PCHB NO. 01-133
PORT OF SEATTLE'S MEMO OPPOSING
ACC'S MOTION FOR STAY

DECLARATION OF
STEVEN G. JONES

Response to Comments

Master Plan Update Improvements at Seattle-Tacoma International Airport

Sea-Tac Third Runway CU Triaxial Data

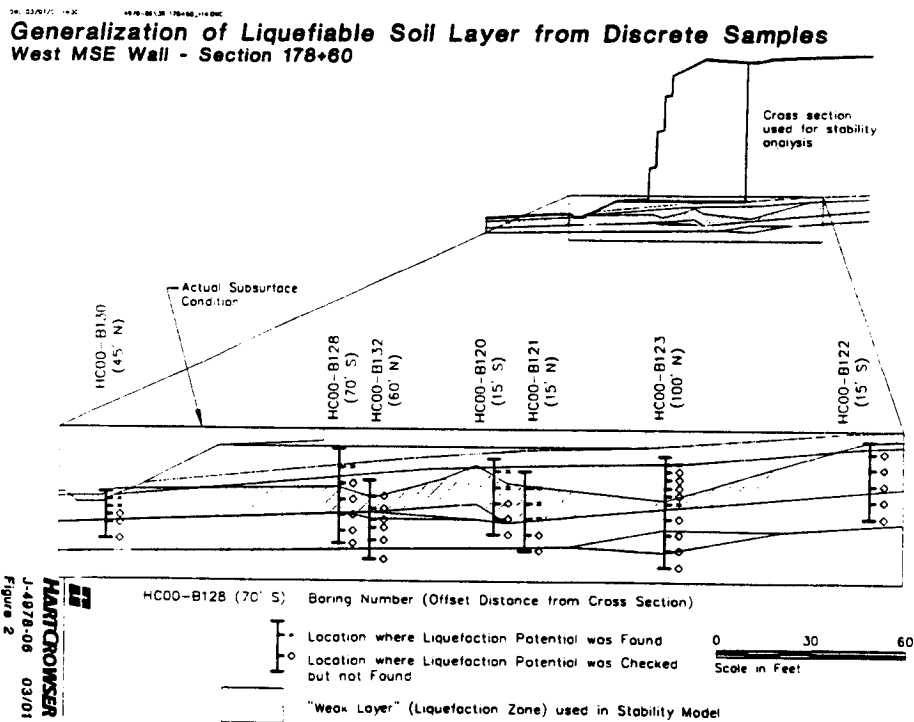
The Port’s design team used soil strength values that are reasonable and appropriate. The Port’s site-specific triaxial CU test data produced effective friction values that ranged from 32 to 35 degrees and show a slightly decreasing trend as the confining pressure increases. Design analyses are based on the extrapolation of available test data to about 12 tsf, which produced an average effective friction angle for fine-grained soils of approximately 32 degrees. See Figure 1. The Port used 32 degrees as the basis for design in its global stability analyses. Moreover, subsequent analyses demonstrated factors of safety greater than 1.0 would result from using even lower values. Thus, the current design provides an additional margin of safety due to the use of this conservative angle of friction.

Note: Stability analyses show margin of safety even if effective friction angle is reduced to 30 degrees.

Figure 1. Functional rankings assigned to wetlands being eliminated for the Third Runway Project.

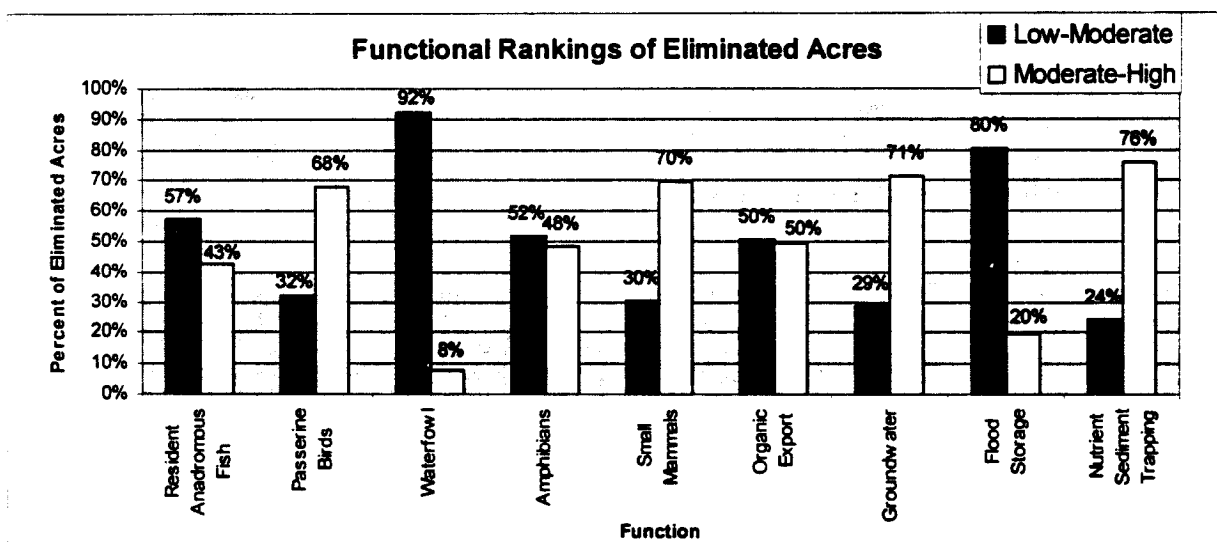
Figure 1 shows that the highest-ranking functions being eliminated from the watershed in the greatest proportion are habitat for passerine birds (68%), small mammals (70%), groundwater discharge/recharge (71%), and nutrient sediment trapping (76%). Forty-three percent of the wetland acres being eliminated are ranked moderate-to-high for anadromous fish habitat, forty-eight percent are ranked moderate-to-high for providing amphibian habitat, and fifty percent are highly valued for export of organic material.

Significantly, 92 percent of the eliminated wetlands are low-to-moderate for waterfowl habitat, and 80 percent are low-to-moderate for flood storage. These are proportionally the *lowest*-ranking functions among all the wetlands being eliminated, yet waterfowl habitat and flood storage are the primary functions targeted for replacement in the NRMP.² The grossly misplaced emphasis makes no environmental sense at all and serves to create the impression of mitigation where no effective mitigation in fact exists. The mitigation proposal appears to be tailored to the needs of the project rather than the requirements of the Clean Water Act.

Figure 2. Department of Ecology (DOE) ratings for wetland acres eliminated.⁴

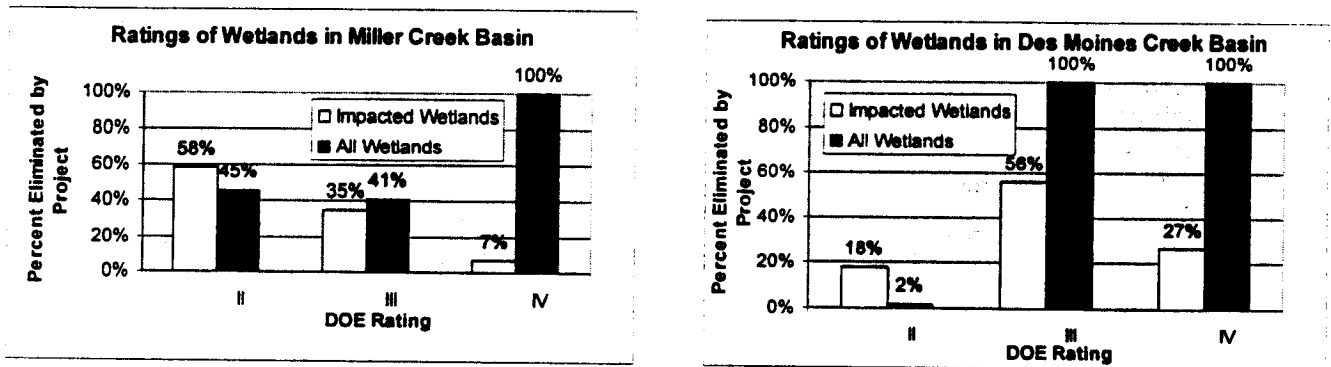
The bar charts in Figure 2 illustrate that the majority of wetland acres being eliminated for the Third Runway project in the Miller Creek watershed are more highly rated Class II wetlands, rather than lower quality Class III and IV wetlands. This evidence directly contradicts the repeated statements

10. It is the Port's belief that the commentor's Figure 2 does not present new information on the scope of wetland impacts. The *Natural Resource Mitigation Plan* Table 3.1-2 (page 3-6) shows the relative impacts to Class II, III and IV wetlands from the Master Plan Update improvements. This *Natural Resource Mitigation Plan* table illustrates that in the Miller Creek basin, 14.37 acres of wetlands will be impacted. 8.37 acres (58 percent) of this area is Class II wetlands, 5.03 acres (35 percent) is Class III, and 0.97 acres (7 percent) is Class IV.

Figure 3. Proportion of wetland habitats eliminated.

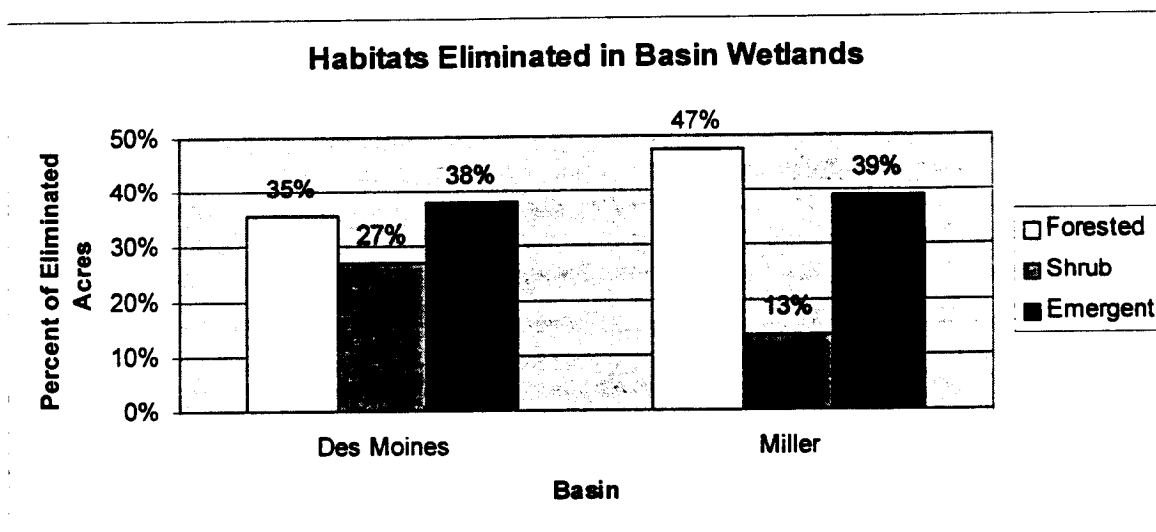
Based on the results revealed in Figures 1, 2 and 3, commensurate mitigation for these lost functions would require replacement of habitat for passerine birds, small mammals, and amphibians. It would require assurances that the sediment and nutrient trapping functions be compensated for, as well as groundwater exchange functions. To comply with Section 404 Guidelines, a plan would have to ensure that sources of organic export within the affected watersheds be maintained and that there be no net loss of fisheries habitat (resident or otherwise), particularly in light of recent and proposed Environmental Species Act (ESA) listings. An acceptable plan would include creation of wetlands rated Class II or greater and would provide habitat dominated by forested and emergent wetland systems.

Figure 5a. Wetland 44 boundaries.

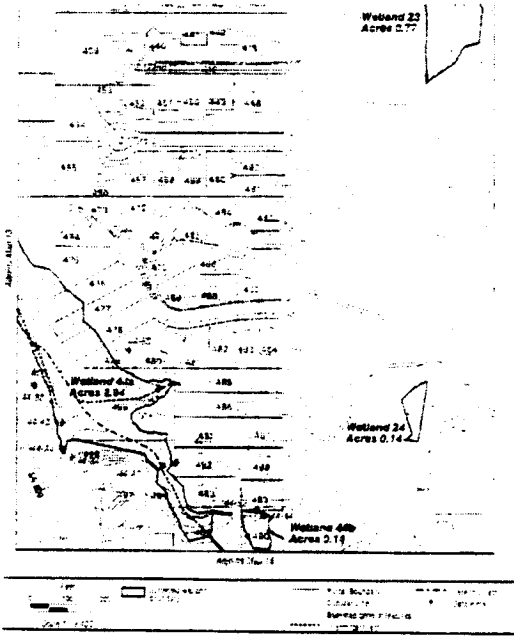
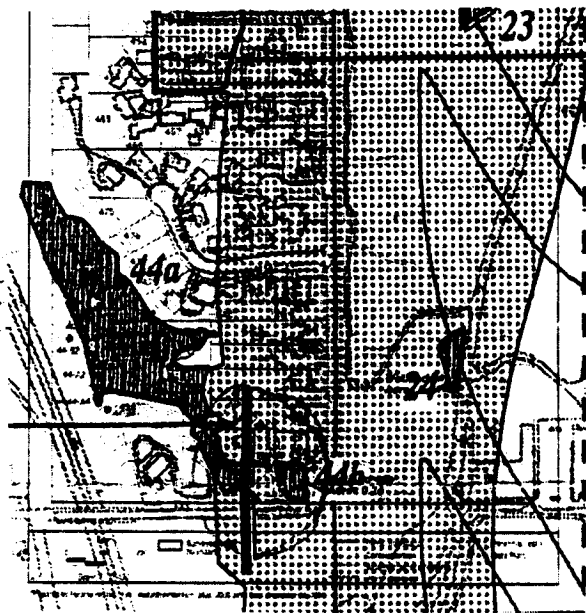
Although the correct information is available in the wetland delineation report, maps of the area in the NRMP shows the headwater of Walker Creek as the outlet of Wetland 43, and the text contained in Section 4.3.2.11 of the Wetland Functional Assessment and Impact Analysis (December 2000) repeats this misrepresentation. The report incorrectly states, "There are no perennial 'headwater seeps' that provide significant base flow to Walker Creek in the area where the embankment fill impacts Wetland 44." In fact, both Map 14 and Image #14 clearly show three tributaries to Walker Creek. Two of them become one perennial stream within the location of the embankment fill. Figure 5a shows the delineated boundary of Wetland 44 presented in Map 14 of the NRMP. Next to it, Figure 5b shows a map of the runway embankment footprint, as shown in Figure 3.1-1 of the NRMP, overlaid on Figure 5a. It shows that the southern-most tributaries are scheduled to be under the embankment fill.

Figure 6a. Map 10 from August 1999 NRMP shows Walker creek channel.

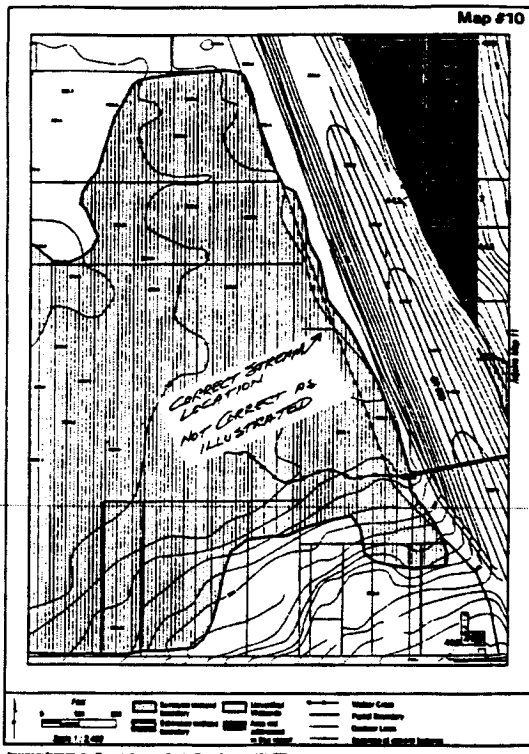
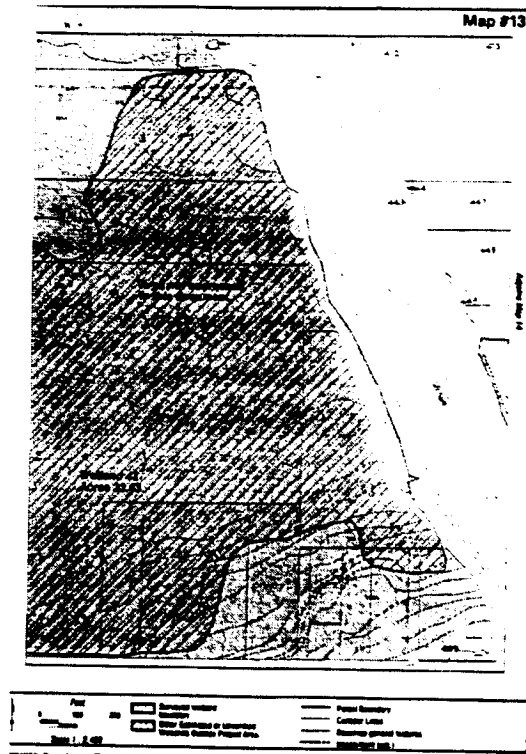
In a previous version of the NRMP (August 1999), Map 10 of the Wetlands Atlas shows Walker Creek originating from the culvert under SR509 and flowing west and northwest until it disappears under the wetland vegetation (provided in Figure 6a). Curiously, this creek channel, which actually exists, is not shown in the December 2000 Wetland Delineation Report map of Wetland 43 (provided in Figure 6b). This conceals the facts that the embankment construction will fill a portion of the headwaters of Walker Creek and that significant disturbance will occur within the remainder of the headwater wetland from construction activities. This serious harm to the headwater of Des Moines Creek hidden in contradictory reports subverts the permit review process.

The NRMP states that the stormwater system of SR509 is the headwater to Walker Creek because of its contribution to Walker Creek flows.²⁵ Although stormwater flows from SR509 may substantially increase Walker Creek, they cannot accurately be construed as the creek headwaters. The landscape position of Wetland 44 in relationship to 43, the presence of a clearly defined channel, and the perennial stream flows cited in the descriptions of Wetland 44 are clear evidence that Walker Creek's headwater is located in Wetland 44 and not in Wetland 43.

Revised Auburn Grading Plan (June 28, 2001):

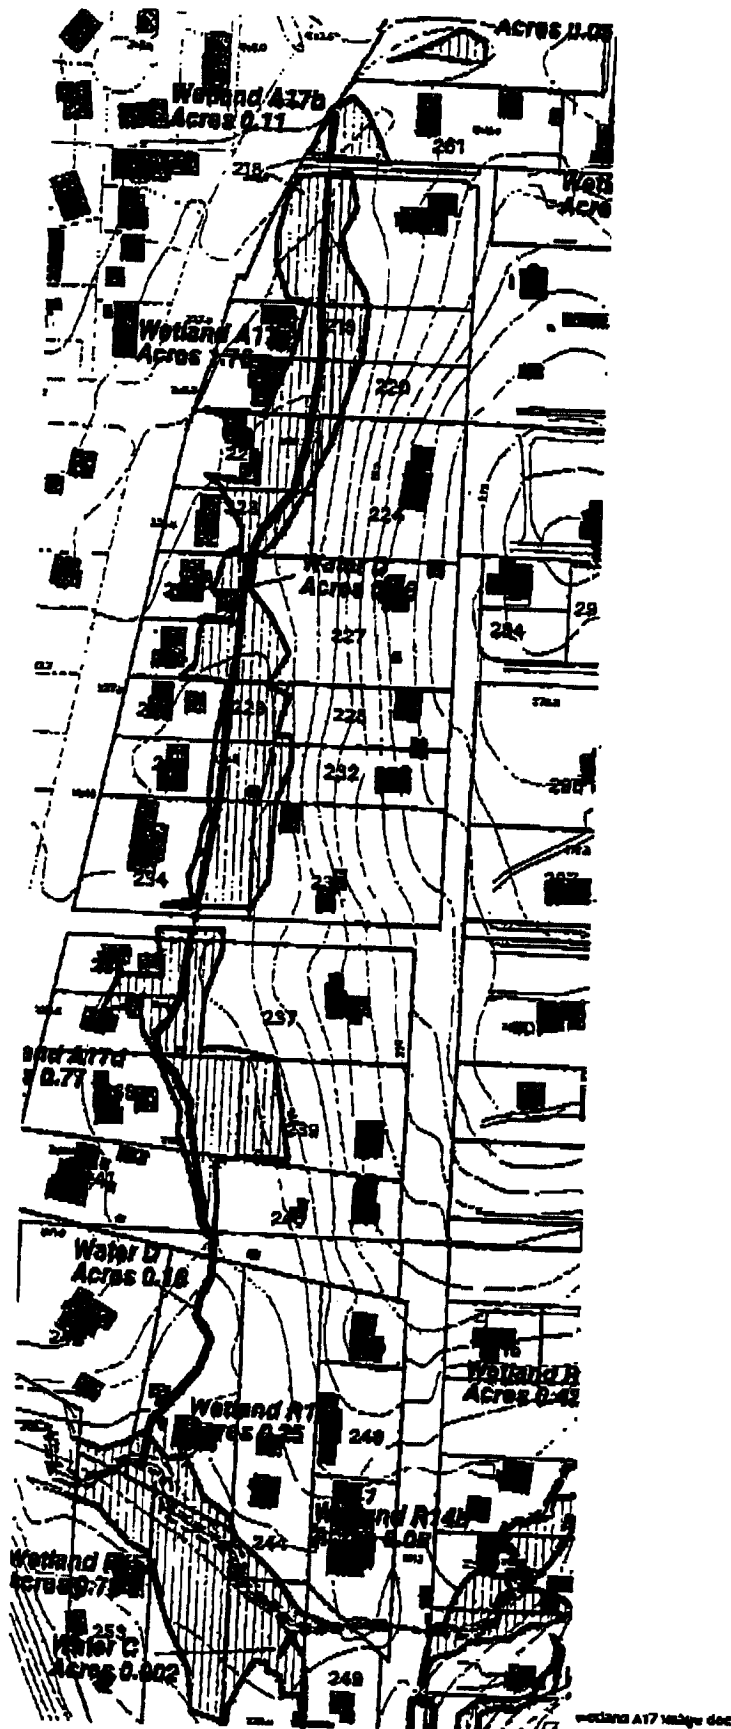
1. The revised grading plan (June 28, 2001) shows a culvert in the northwest corner of the site in the proposed new drainage swale. The culvert will pass flows under the site access path. The drawing shows this culvert approximately 60 feet long, passing under a path that is only approximately 15 feet wide. This culvert should be no longer than is necessary to pass the water under this pathway.
2. The revised grading plan (June 28, 2001) shows a culvert in the south central portion of the mitigation site. This culvert appears to be mis-located. It appears that the culvert should be shown in the wetland directly east of the shown location, where the wetland passes under the
